VICTORIA EMBANKMENT FORESHORE AND BLACKFRIARS BRIDGE FORESHORE APPLICATION STATEMENT

**To support a proposed non-material amendment
to the Thames Water Utilities (Thames Tideway
Tunnel) Order 2014 (as amended)**

Name	Data
Document ref:	2530-TDWAY-TTTUN-990-ZZ-RG-704430
Legacy document ID:	
Document type:	Report
WBS Code:	n/a
Owner:	Roger Bailey
Author:	Liz Wood-Griffiths
Keywords:

Appendix A
Drawing 4601-FLOJV-BLABF-150-ZZ-DR-400300

2 DETAIL 01
Scale 1:100

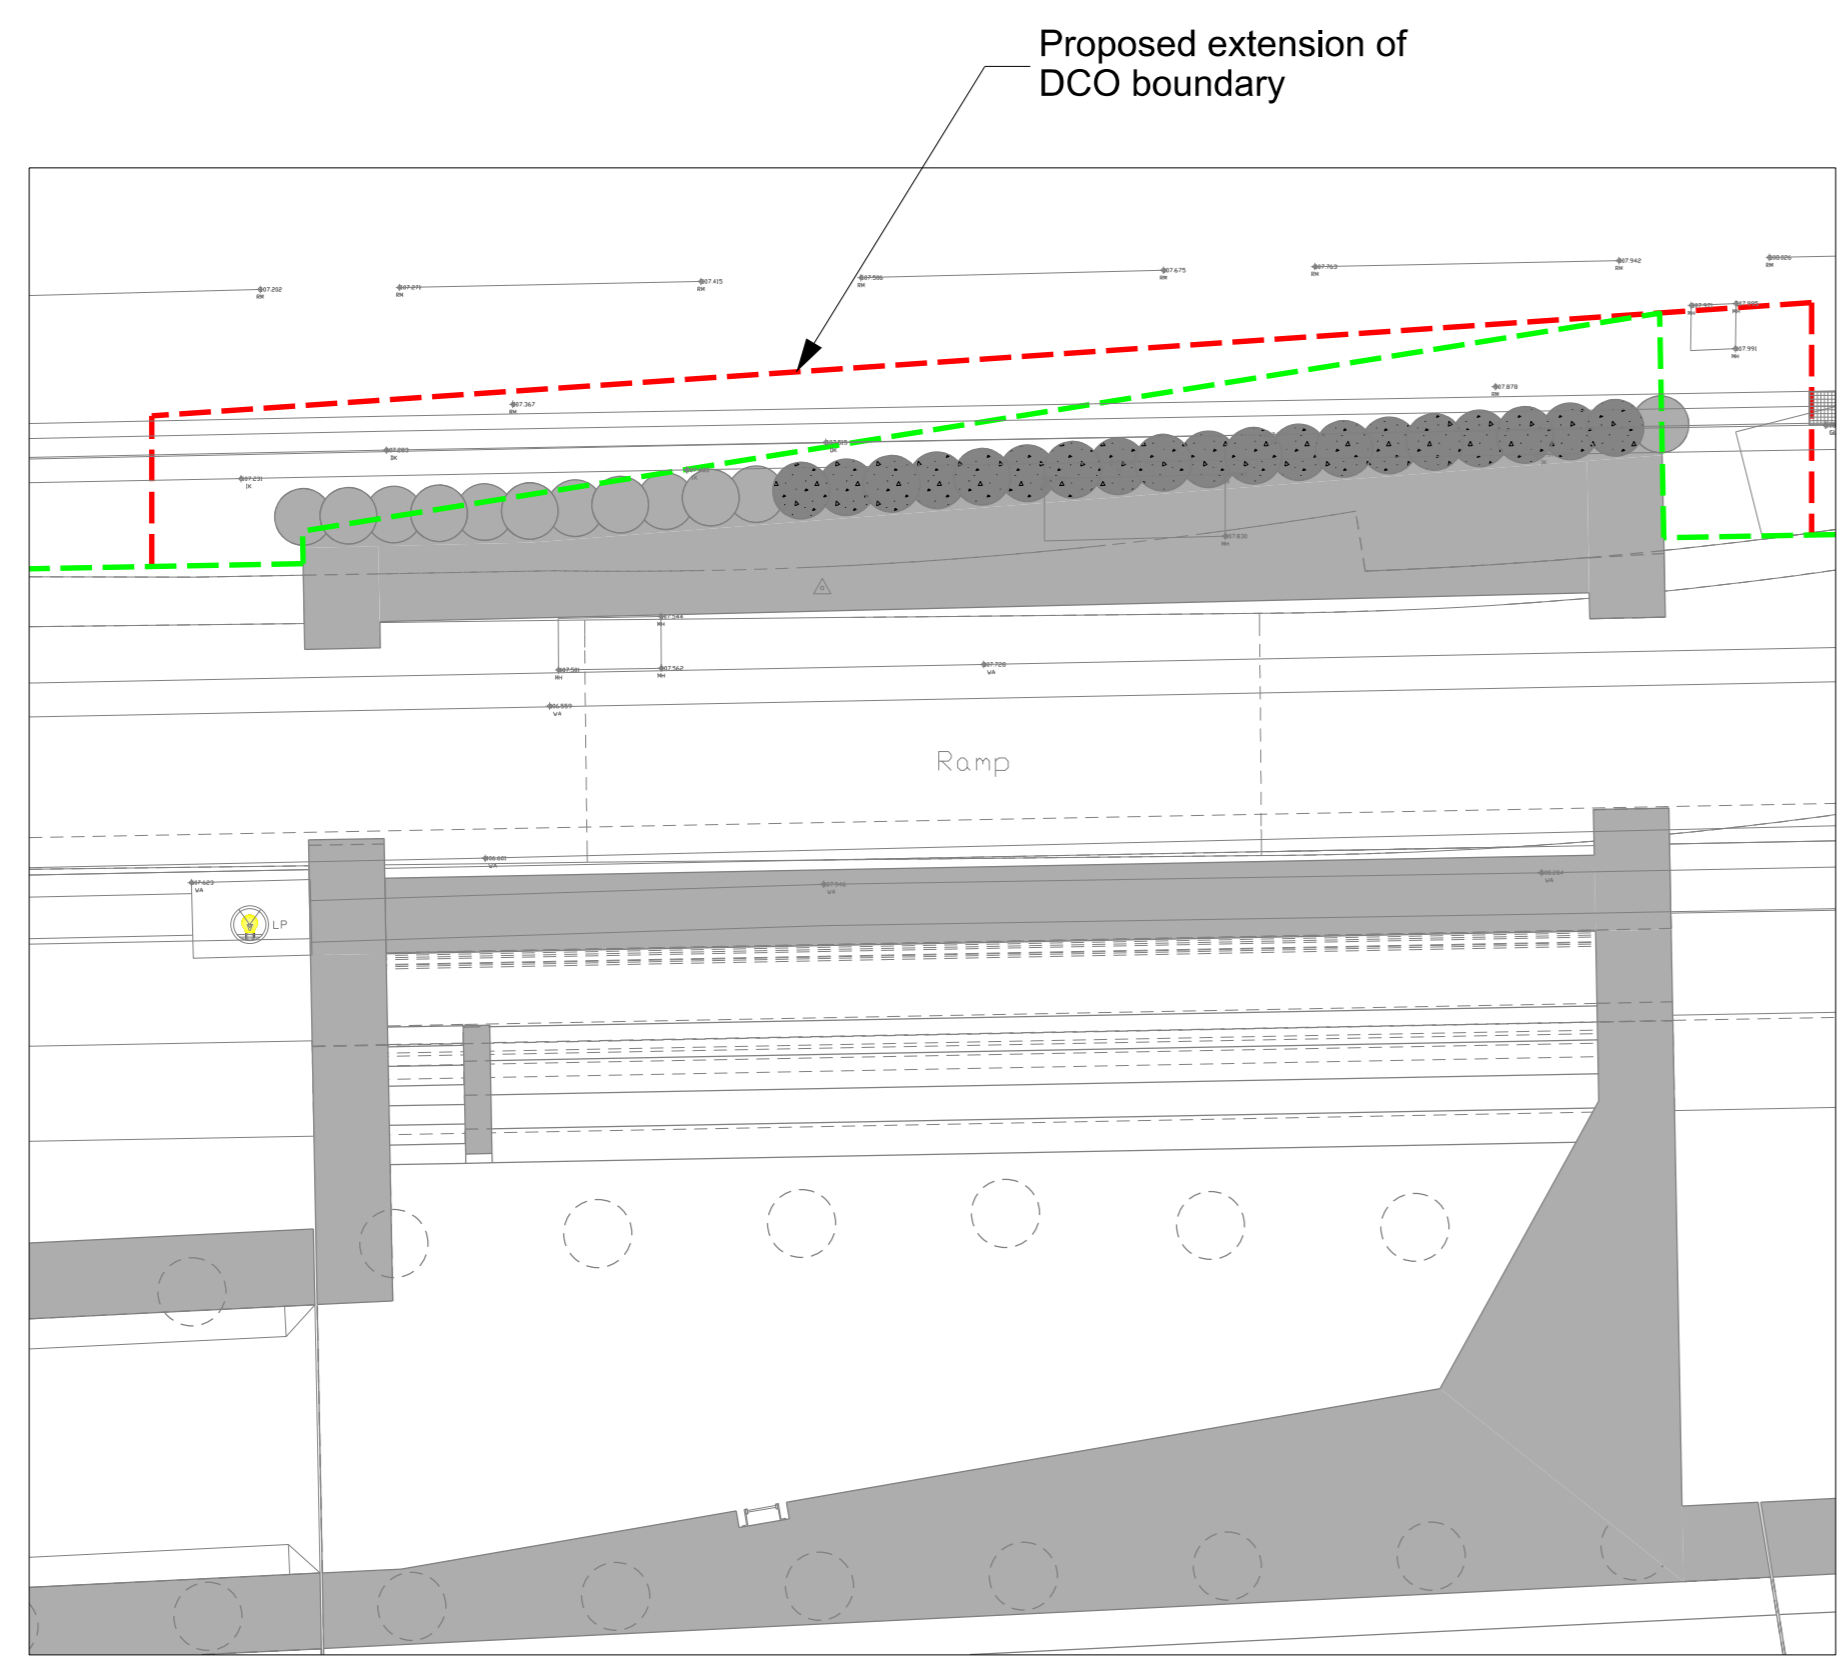
3.2.7 An amendment is proposed in the area of the site where the existing Low Level Sewer No. 1 is intercepted as shown by the red dashed line in Detail 01 on drawing 4601-FLOJV-BLABF-150-ZZ-DR-400300. The amendment is required to enable the piled wall that will provide ground support during the construction of the overflow weir chamber works to be retained as part of the final design solution. The green zone boundary on the approved plan was based on the outline DCO design and information about the sewer and utility subway available at the time of the DCO application. Subsequent surveys have identified the presence of a redundant access shaft which projects beyond the envelope of the utility subway. This, in conjunction with further design development means that some of the

permanent works piles will fall outside or partly outside of the green zone. The minor adjustment to the green zone proposed will allow any piles required for ground support to be retained as part of the permanent works for the new integrated structure. It also provides the necessary flexibility to accommodate any small increases to the width of the integrated structure that may be required due to associated design development. Thames Water currently benefits from an agreement with the City of London which governs the permanent acquisition of land in this area, and as a result there is no need to amend or extend the powers under the DCO relating to permanent acquisition.

3 DETAIL 02
Scale 1:100

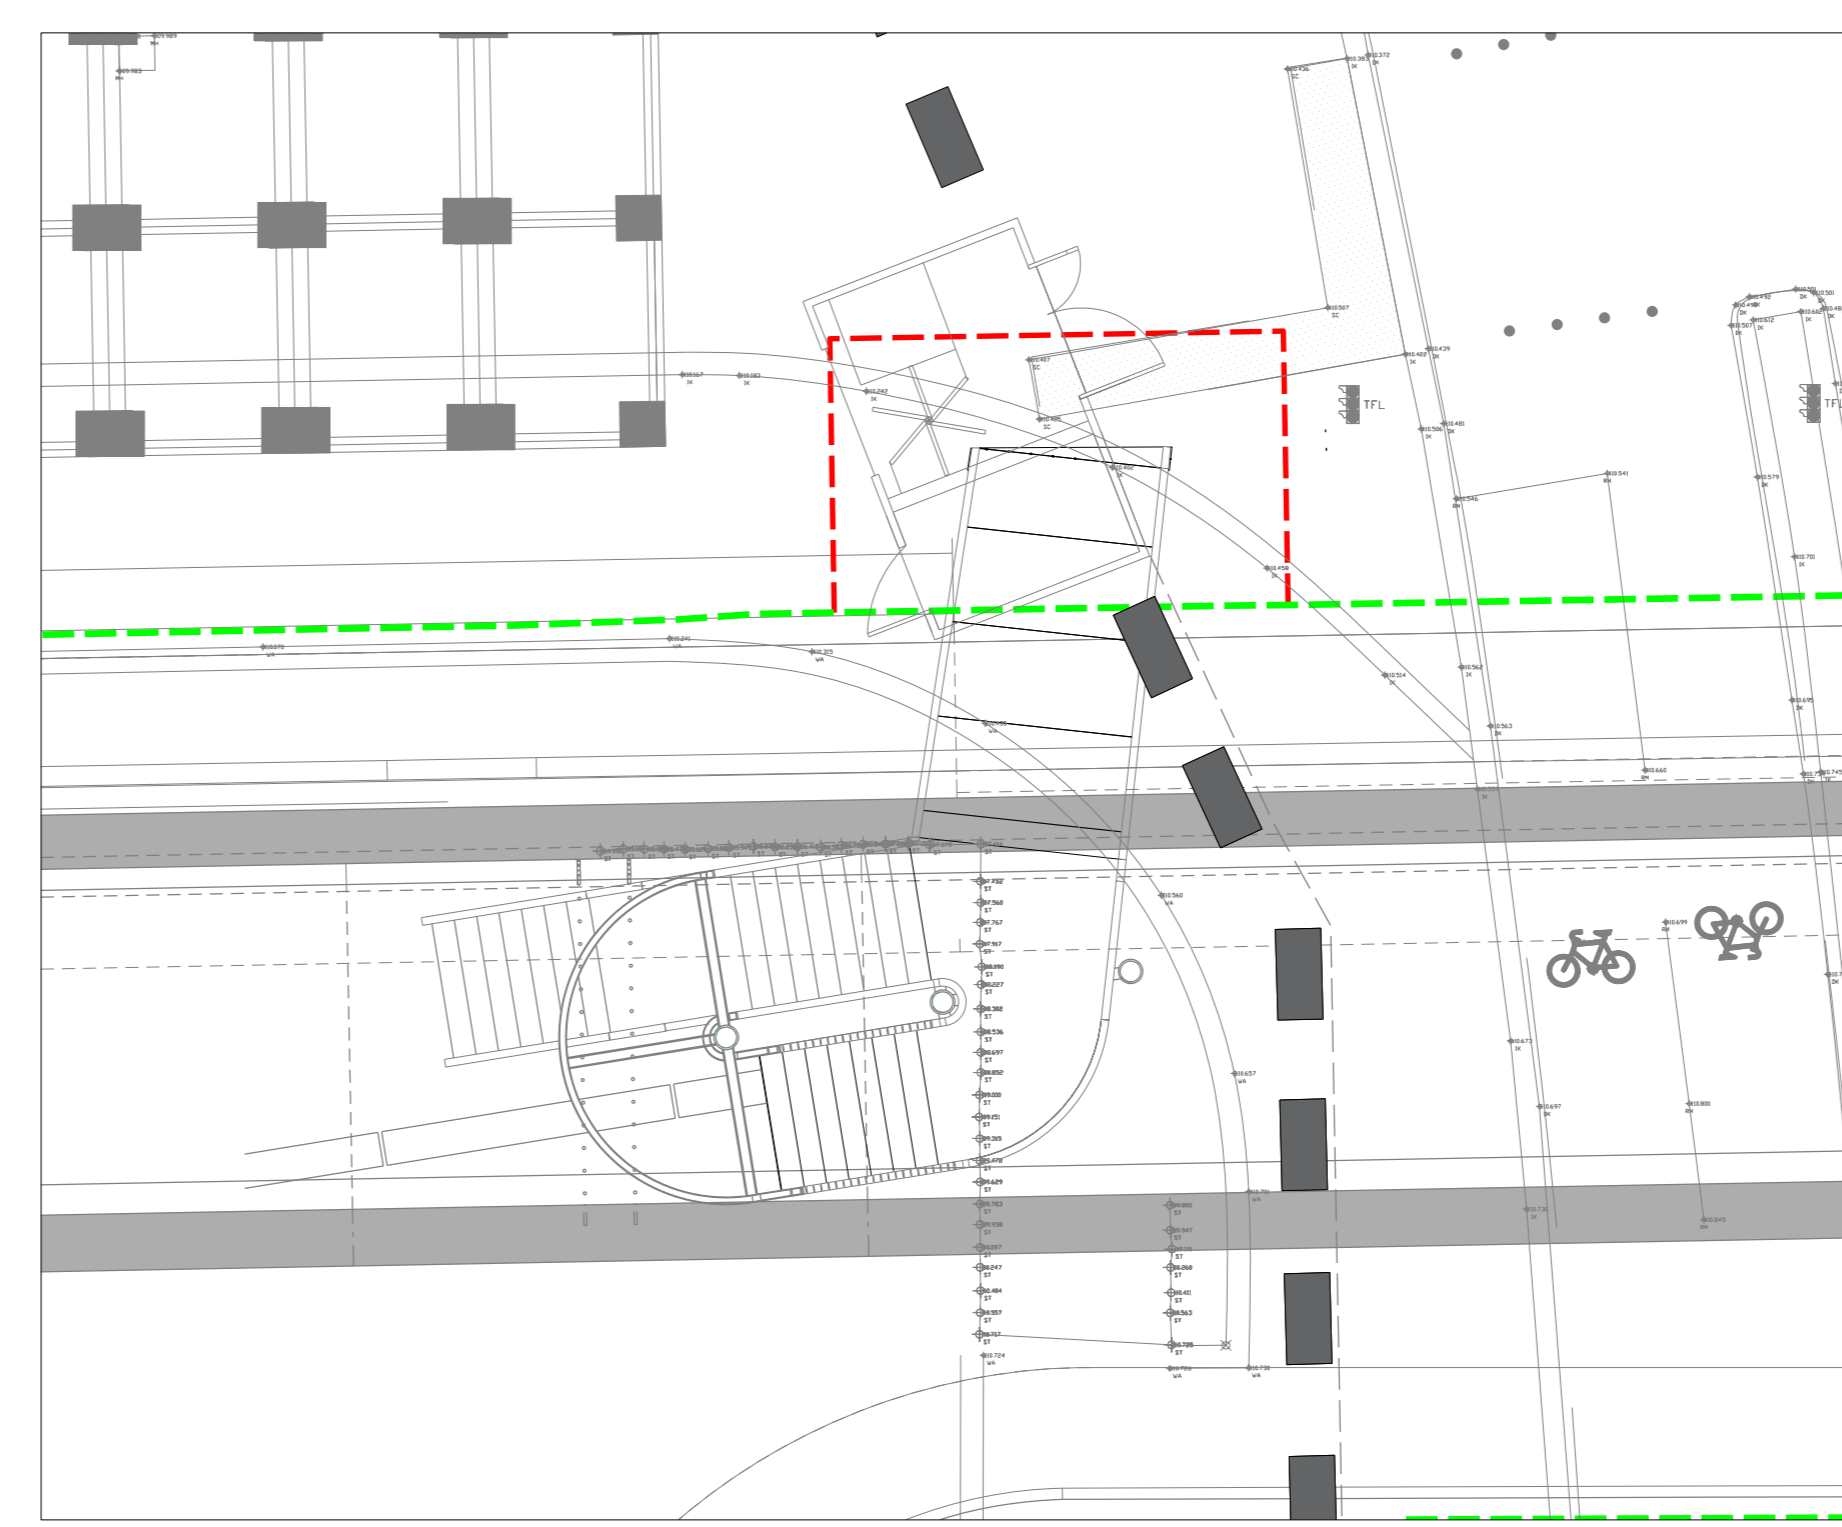
- 3.2.8 A further adjustment to the green zone is proposed in the area of the site where replacement stairs are being constructed to the west of Blackfriars Bridge. At this location, the authorised development provides for works to remove and relocate the existing stairs on the west side of the bridge from the Thames Path and subway and Blackfriars Road Bridge. An elevated walkway links the existing stairs to the subway which provides a pedestrian route beneath Victoria Embankment to Blackfriars Station and the A201. To facilitate construction of the relocated staircase a portion of the elevated walkway needs to be demolished and reinstated.

- 3.2.9 The indicative design of the staircase submitted with the DCO application has been developed in consultation with the City of London and Historic England to provide improvements to the finish and configuration of the reinstated staircase. The staircase will be orientated so that pedestrians are directed from the staircase onto the new foreshore structure, and the elevated walkway (which links the existing stairs to the subway to provide a pedestrian route beneath Victoria Embankment to Blackfriars Station and the A201) will match the finish of the reinstated stairs.

- 3.2.10 Although the new parts of the elevated walkway will be reinstatement of an existing structure, it could also be argued that they form part of the new staircase structure and are therefore a permanent site structure for the purposes of the DCO. As currently drawn, part of the reinstated walkway falls outside of the green zone. It is therefore proposed to extend the green zone in this location (as shown by the red dashed line in Detail 02 on drawing 4601-FLOJV-BLABF-150-ZZ-DR-400300) so that the full extent of the elevated walkway to be reconstructed is included in the parameter. This will avoid any potential for ambiguity around the approval of the reinstated walkway.
